HISTORIC PRESERVATION BOARD STAFF REPORT

102 NE 7th Street		
Meeting	File No.	Application Type
July 1, 2026	HP-511-2026	Certificate of Appropriateness and Variance

The item before the Board for consideration of a Certificate of Appropriateness (HP-511-2026), and Variance request for exterior modifications and an addition to the rear of the existing contributing structure for the property located at **102 NE 7th Street, Del-Ida Park Historic District.**

DRAWN BY: YG
CHECKED BY: RL
DATE: 02/11/2026
SCALE: AS SHOWN
JOB NO:
SHEET **SP-1**

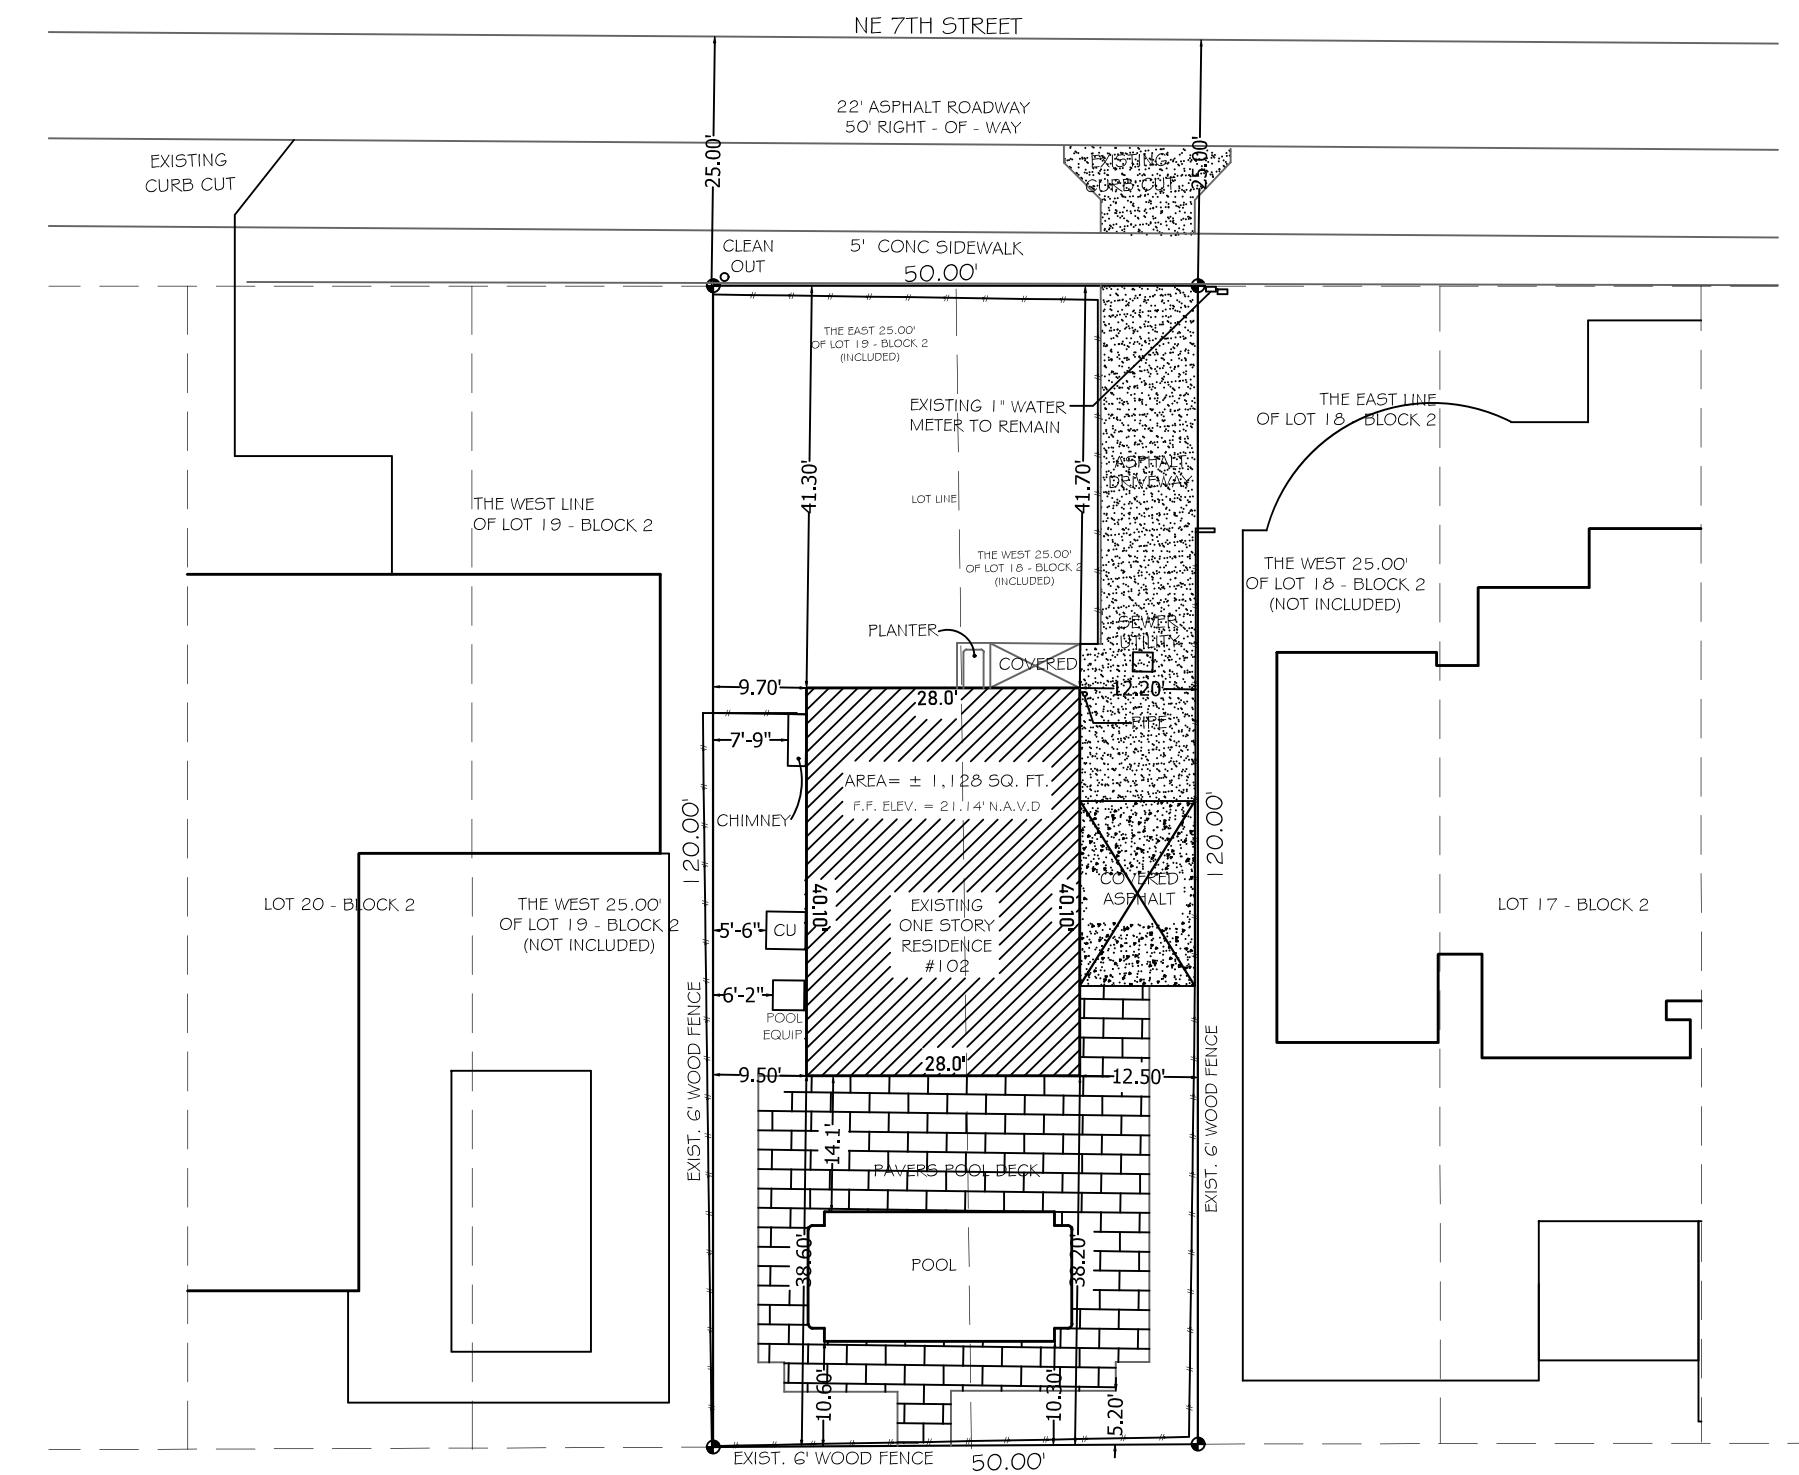
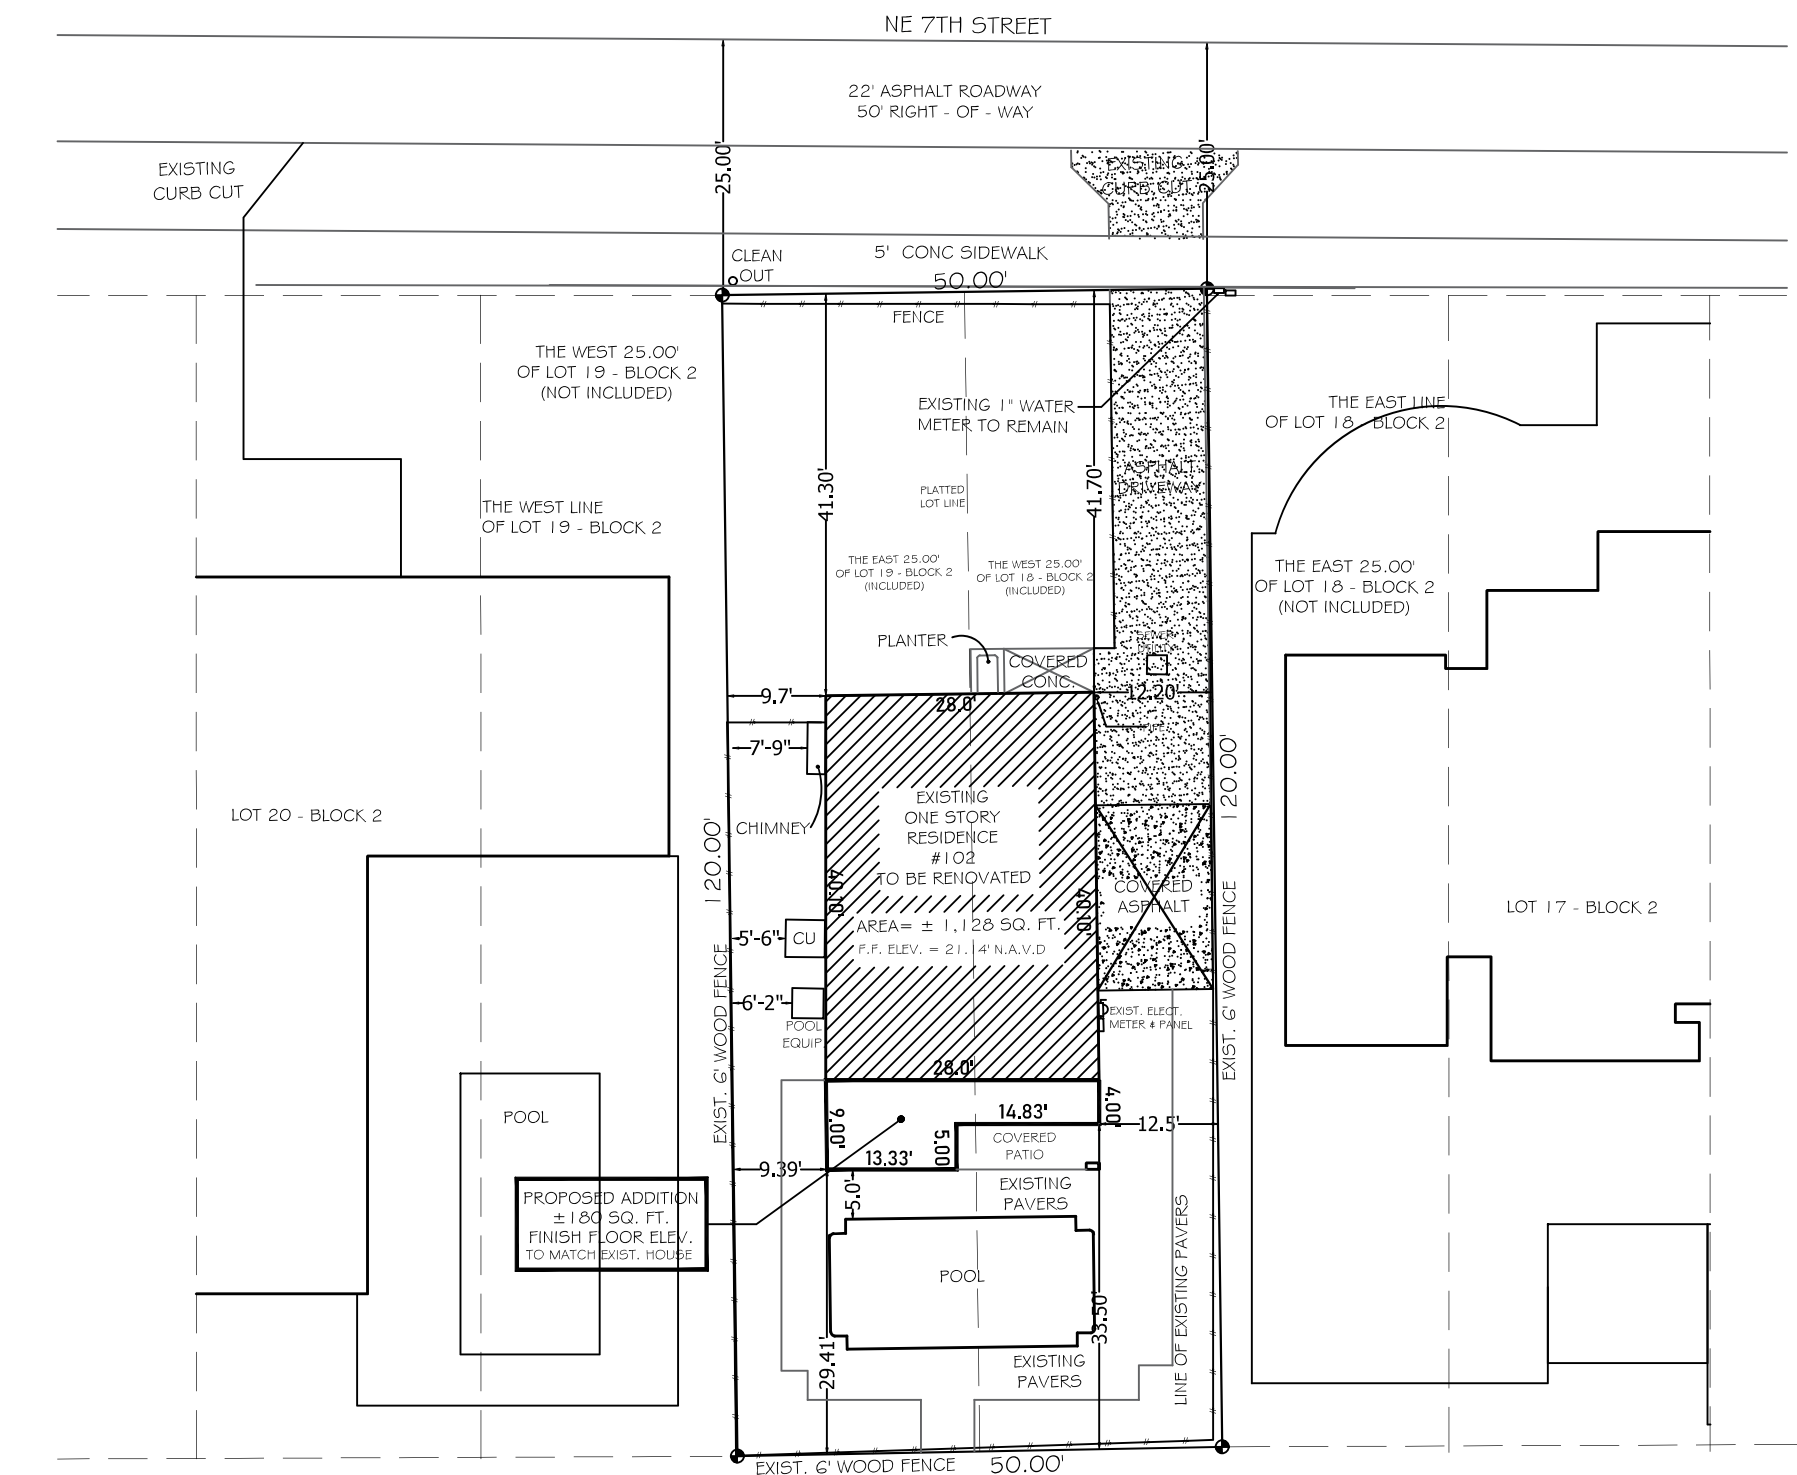
1. Show the location of the existing ROW cleanout and sewer lateral on the site plan;
2. The meter size, if only 3/4" is upsized to a minimum 1".
3. Provide call-out for all fencing on site plan.

EXISTING / NORTH ELEVATION

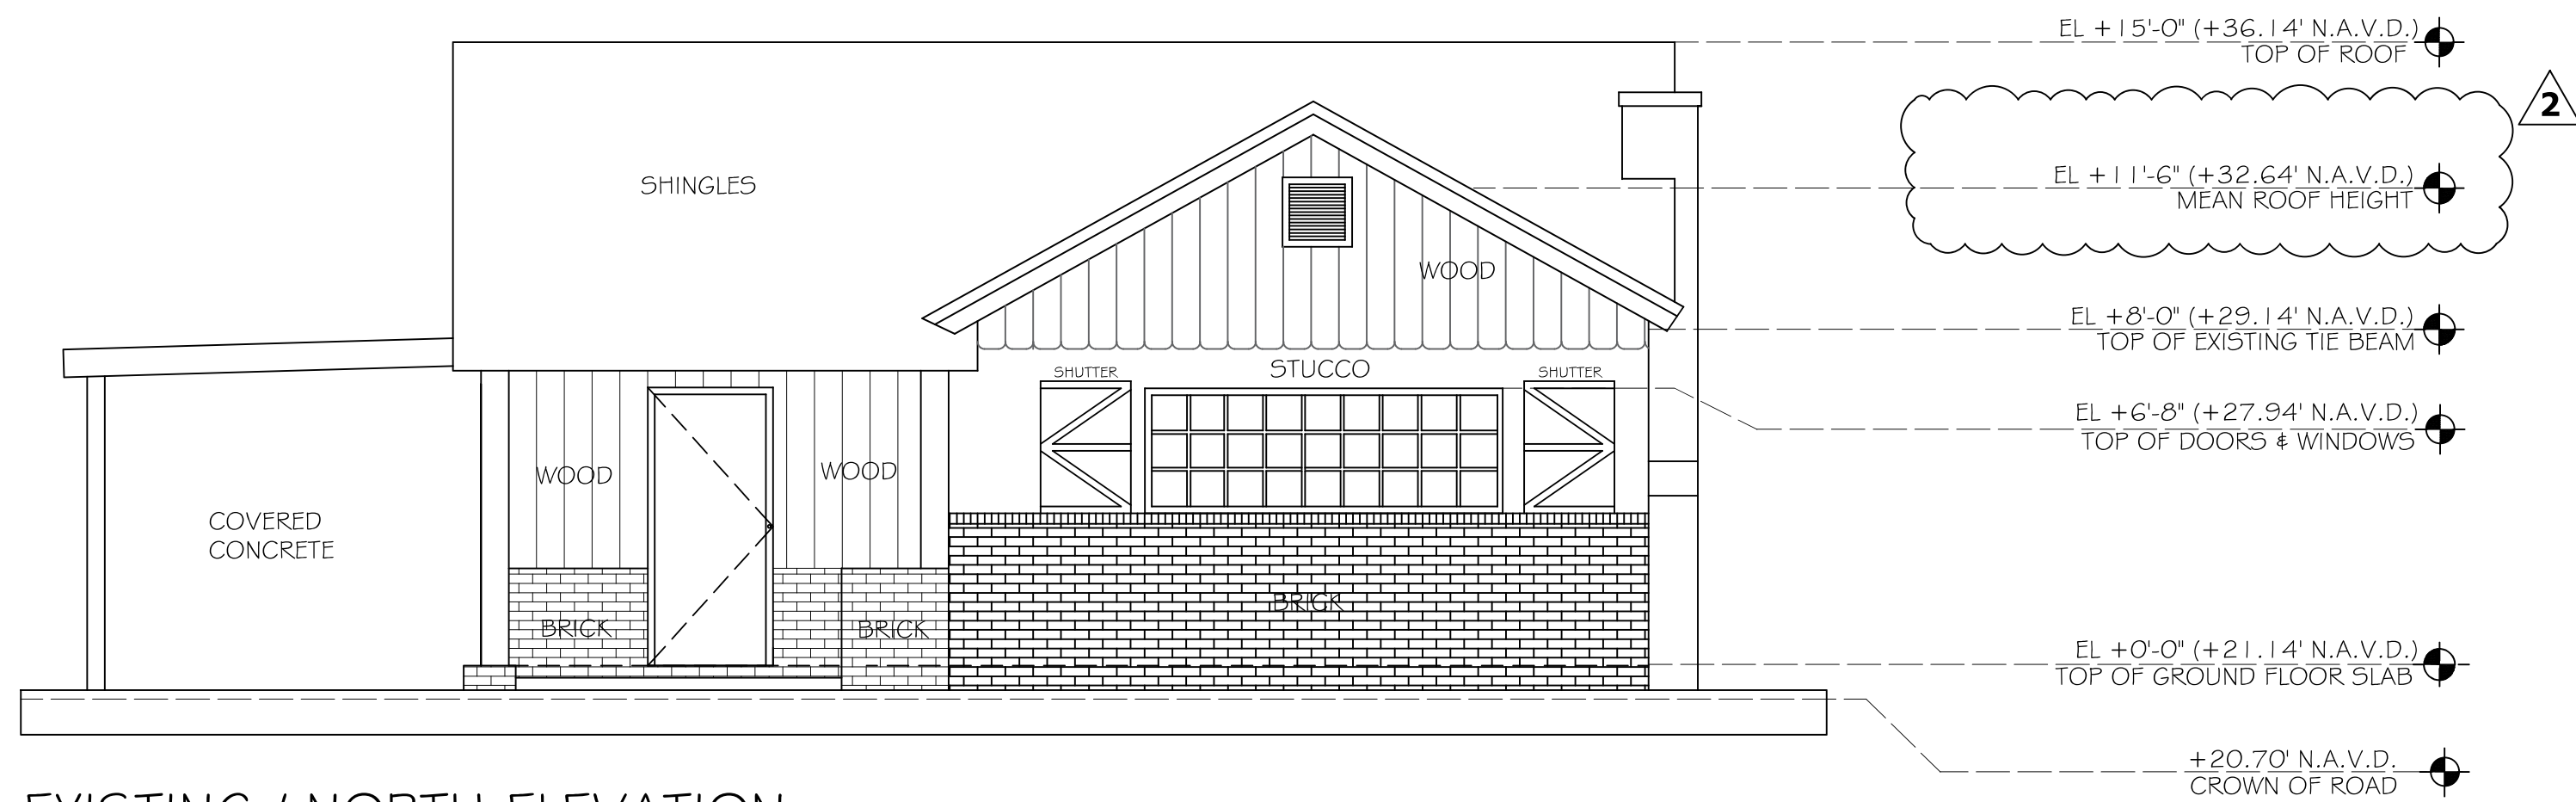
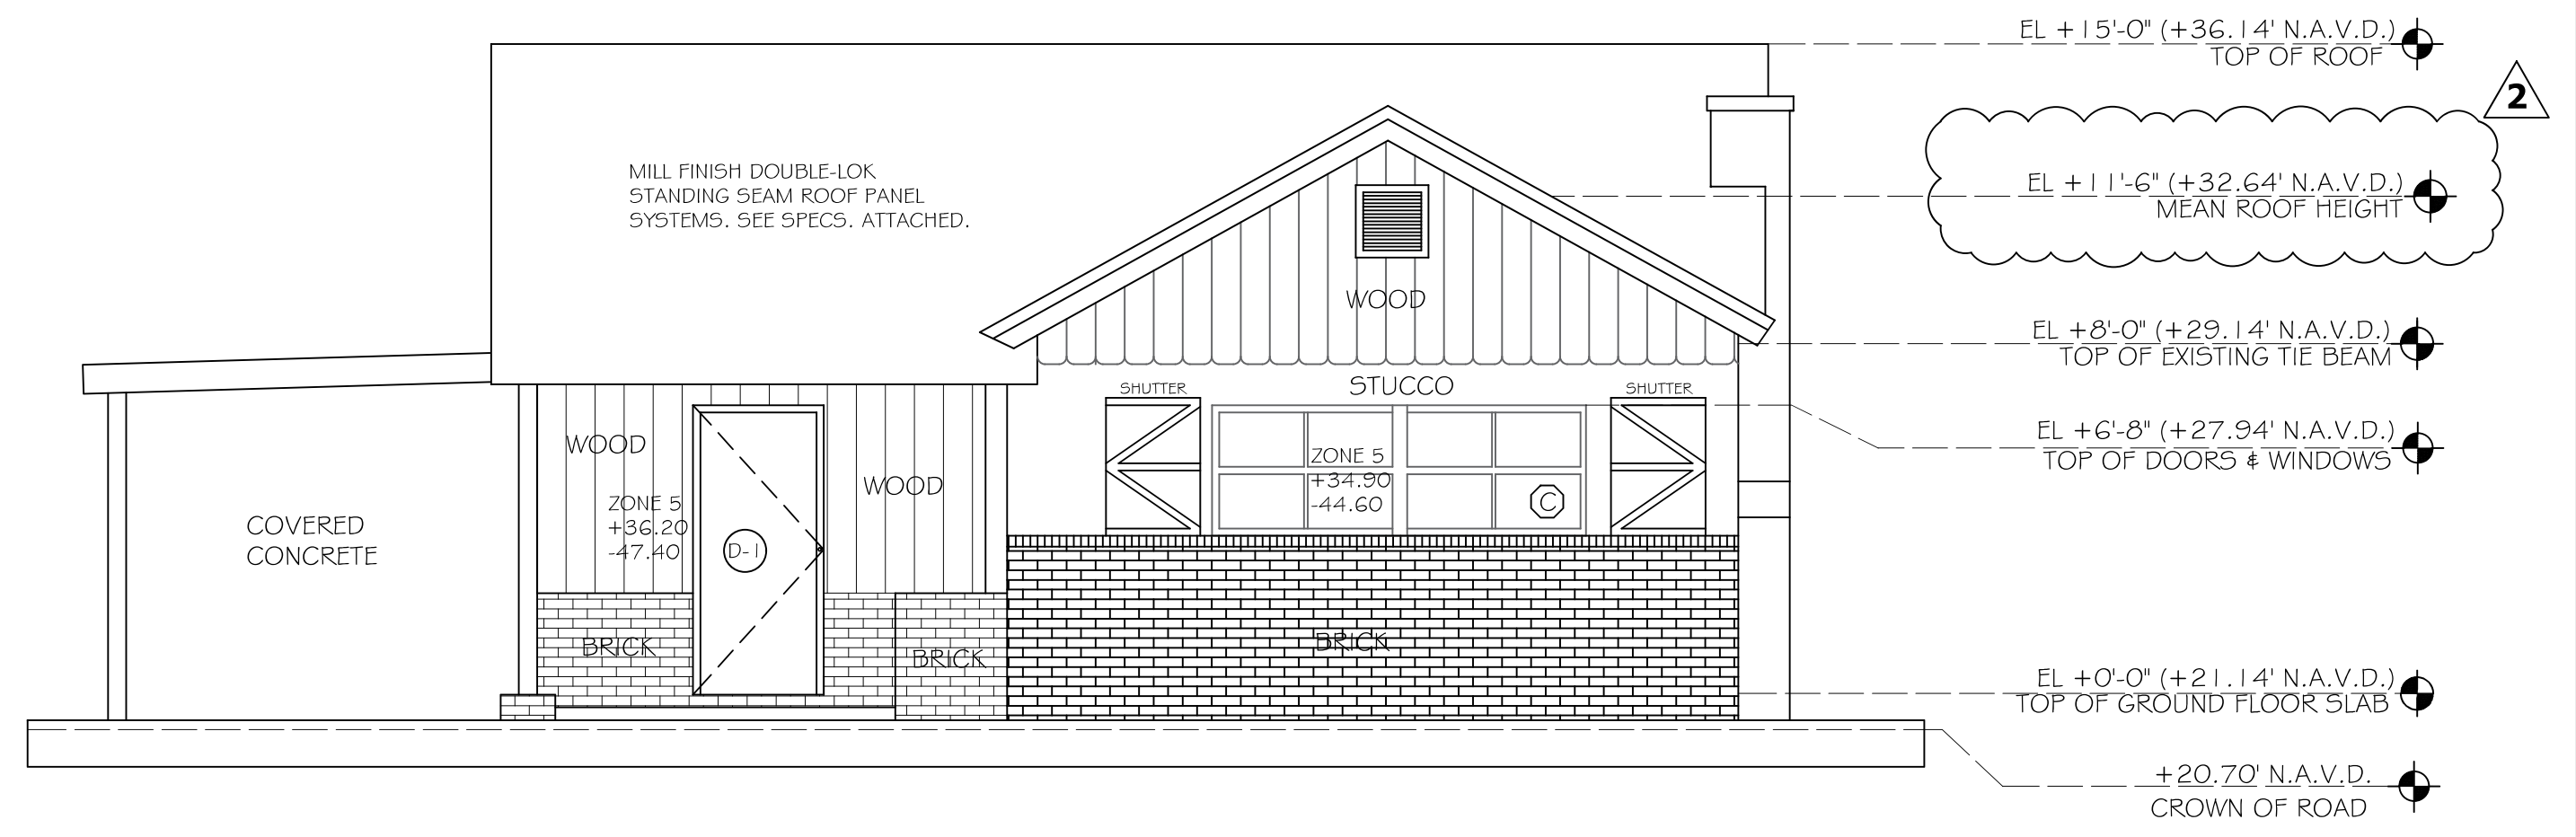
- Front (North) – Replacement of the existing nine by three muntin window, with two two-over-two single hung windows
- Side Interior (East) – Replacement of the existing four by three and two by three windows, with two two-over-two single hung windows. Removal of a four by three window in the rear for two two-over-two single hung windows;
- Side Interior (West) – Replacement of the existing four by three window with a three-over-three single-hung window. Removal of a three by three and six by three window for four two-over-two single hung windows.
- Rear (South) – Removal of all openings to accommodate the addition. Two sliding glass doors are proposed where two sliding glass doors were existing.

As previously mentioned, there is concern with the removal of the existing muntins and modification of the existing **proportion of openings**, although the proposal does retain some muntin pattern. Existing window opening should be retained where possible when accommodating additions. It is noted however that some of the window openings along the side of the home are not visible from the public right-of-way. The existing window size, scale and orientation are horizontal, where there are new windows openings that are more vertical in nature and orientation.

Consideration should be given to retaining existing window openings and the use of dimensional muntins that are as close as possible to the existing window pattern. Additional modifications to the windows include the removal of all of the existing shutters, except for two on the front (north) elevation. While shutters are commonly seen on Minimal Traditional style structures, the shutters currently existing on the structure do not appear functional as most are not half the width of the window, overlap with each other, lack the use of shutter dogs, and look more modern in style. The removal of the shutters in the front could be deemed appropriate, as they do not appear functional due to their size.
